## STAFF REPORT

### Site Plan & Architectural Review

**LOCATION:** 815 S Broadway, Coos Bay, Oregon 97420  
T. 25S, R. 13W, S. 35BD, Tax Lot 4800

**SUBJECT:** **Site Plan and Architectural Review (SPAR) #187-ZON15-015**  
**Retail Sales**

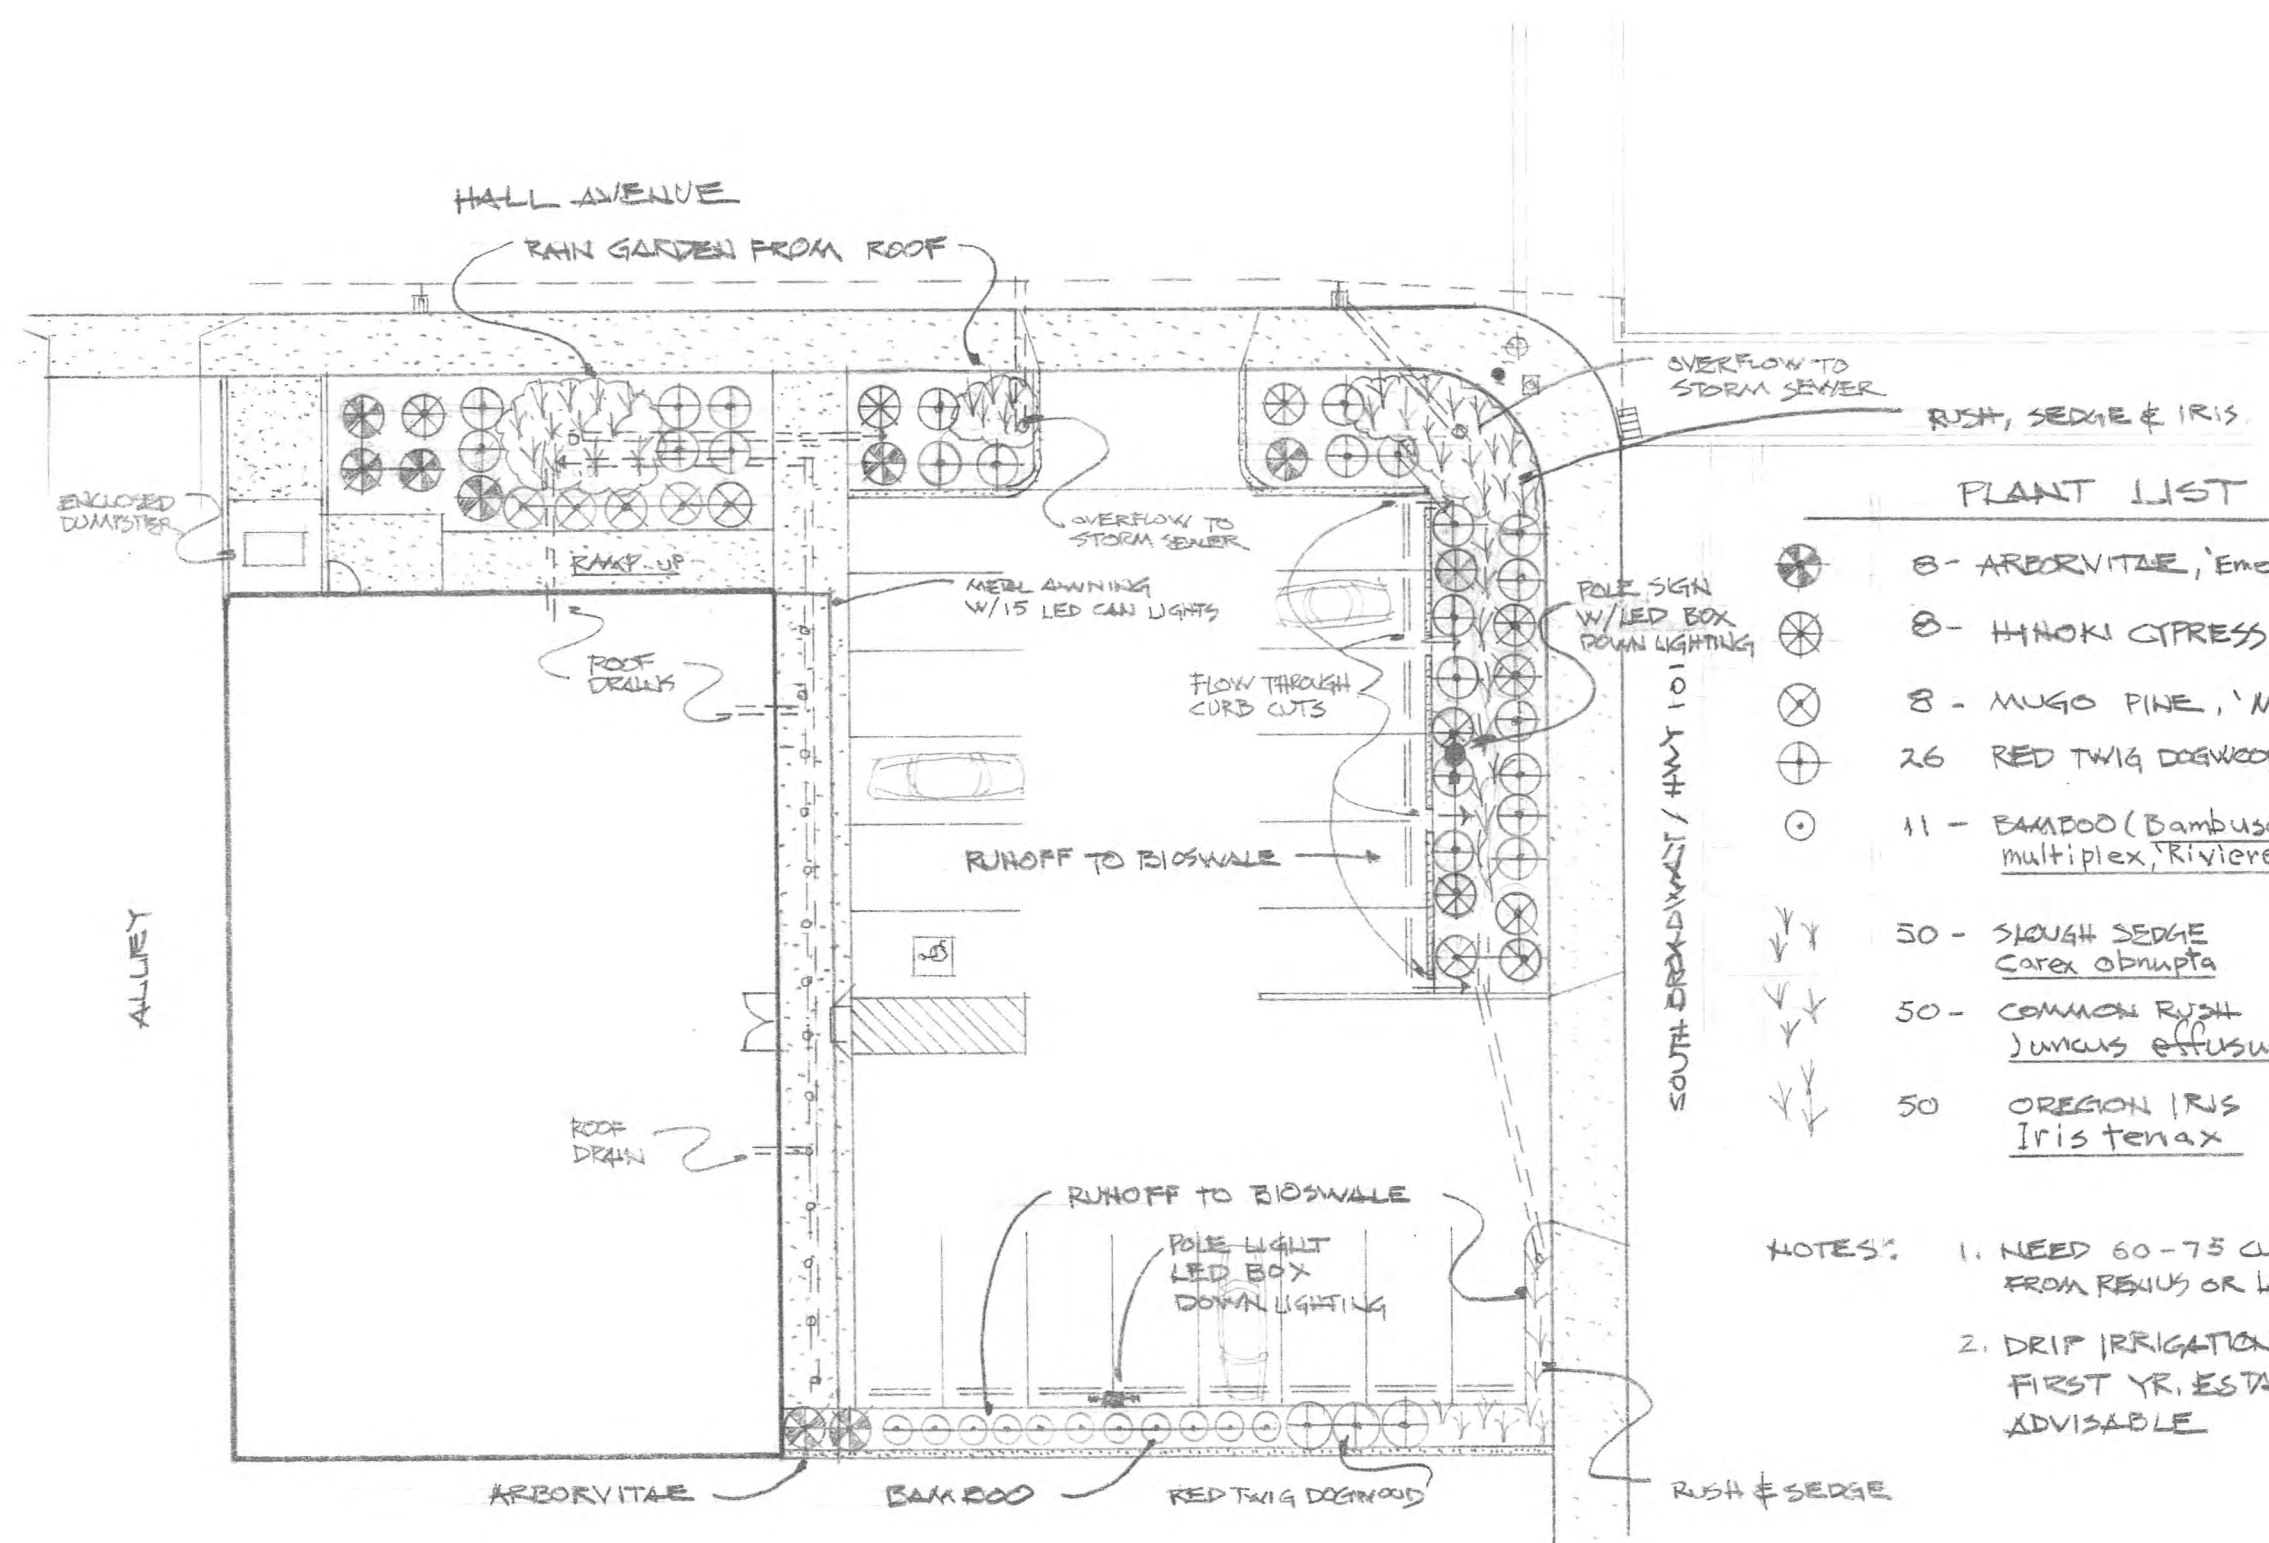
According to the Oregon Transportation Commission's Standards for Accessible Parking Places (May 2012), the proposed handicap parking space does not comply with standards. The access aisle and ramp shall be located on the north side of the accessible parking place.

- 7c. A proposed wall mounted sign is indicated on the elevation drawings. Wall mounted signs do not count against allowed signage, but a permit is required prior to installing the sign. No information was provided for the “pole mounted sign” indicated on the site plan.

1. Compliance with ADA parking standards is required prior to issuance of any building permits. The access aisle and ramp shall be located on the north side of the accessible parking place.
2. All landscaping must be maintained in good condition.

4. Compliance with ADA parking standards shall be verified prior to issuance of any building permits. The access aisle and ramp shall be located on the north side of the accessible parking place.

**GRADING & EROSION CONTROL PLAN**

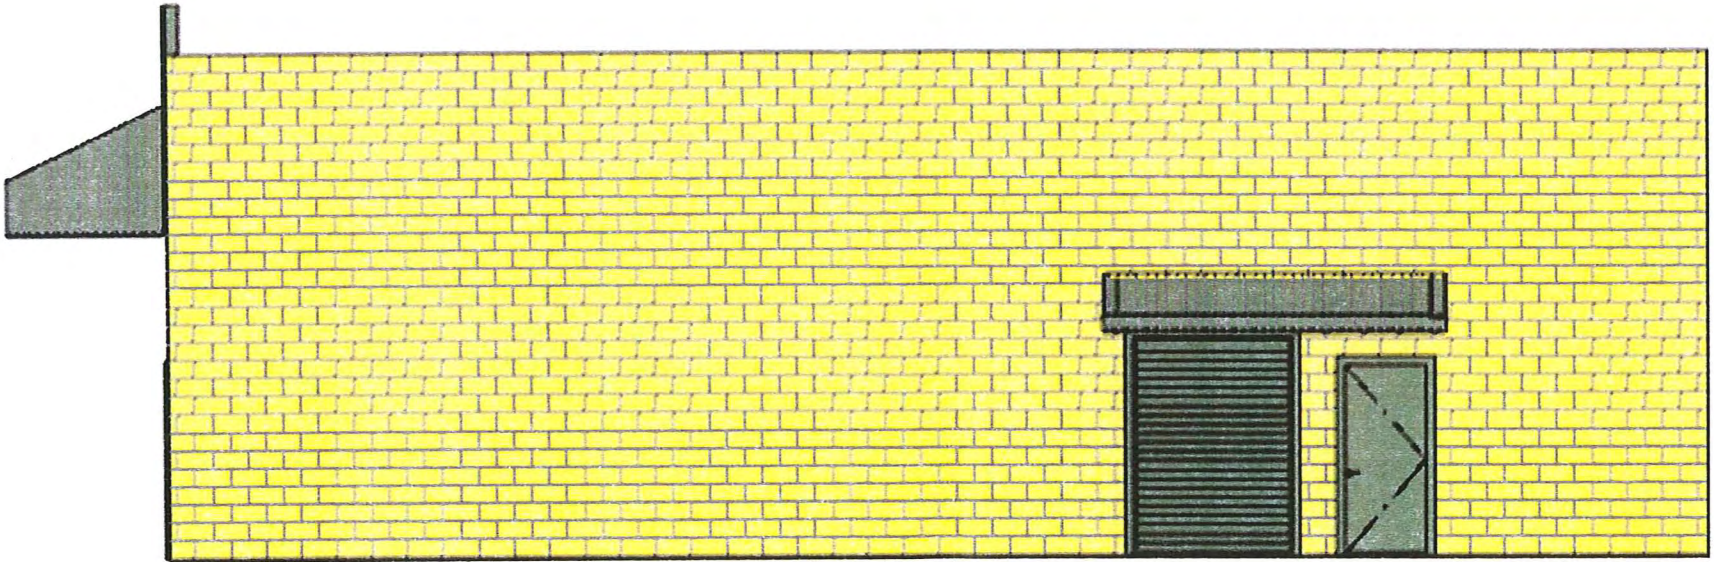
**CONCLUSION:** It is recommended that a trench drain be installed at the driveway entrance along South Broadway to capture the storm water runoff and convey this runoff to the bio-swales. If this is implemented, the bio-swales would treat 100 percent of the project site. Connections to the storm sewer system must be in conformance with both local and state requirements. A complete review for fire protection will be conducted at the time construction plans are submitted. Staff concurs that the proposed use will meet the city standards regarding water and sewer facilities prior to construction. The decision criteria have been adequately addressed and approval of the proposal can be supported.

The site is implementing bio-swales and as such the project anticipates less storm water runoff than the pre-project condition. The bio-swales will also have water quality benefit. It is recommended that a trench drain be installed at the driveway entrance along South Broadway to capture the storm water runoff and convey this runoff to the bio-swales. If this is implemented, the bio-swales would treat 100 percent of the project site.

The site is located in a Federal Emergency Management Agency defined 100-year Zone AE floodplain. The 100-year water surface elevation is 13 feet (NAVD 88). The project must comply with Coos Bay Municipal Code Section 17.195. No information was provided with application that addresses this code. Prior to issuance of permits, project shall provide support that it is in compliance with code and that the grading of the site is not adversely impacting neighboring properties and public right of way. At a minimum the supporting analysis shall demonstrate that the "cumulative effect of the proposed development when combined with all other existing and anticipated development will not increase the water surface elevation of the base flood more than one foot at any point within the community".

1. Applicant shall obtain approval of a grading and demolition permit from the City of Coos Bay prior to beginning work.
2. The site is implementing bio-swales and as such the project anticipates less storm water runoff than the pre-project condition. The bio-swales will also have water quality benefit. It is recommended that a trench drain be installed at the driveway entrance along South Broadway to capture the storm water runoff and convey this runoff to the bio-swales. If this is implemented, the bio-swales would treat 100 percent of the project site.

3. Prior to issuance of permits, project shall provide support that it is in compliance with code and that the grading of the site is not adversely impacting neighboring properties and public right of way and supporting analysis shall demonstrate that the “cumulative effect of the proposed development when combined with all other existing and anticipated development will not increase the water surface elevation of the base flood more than one foot at any point within the community”.
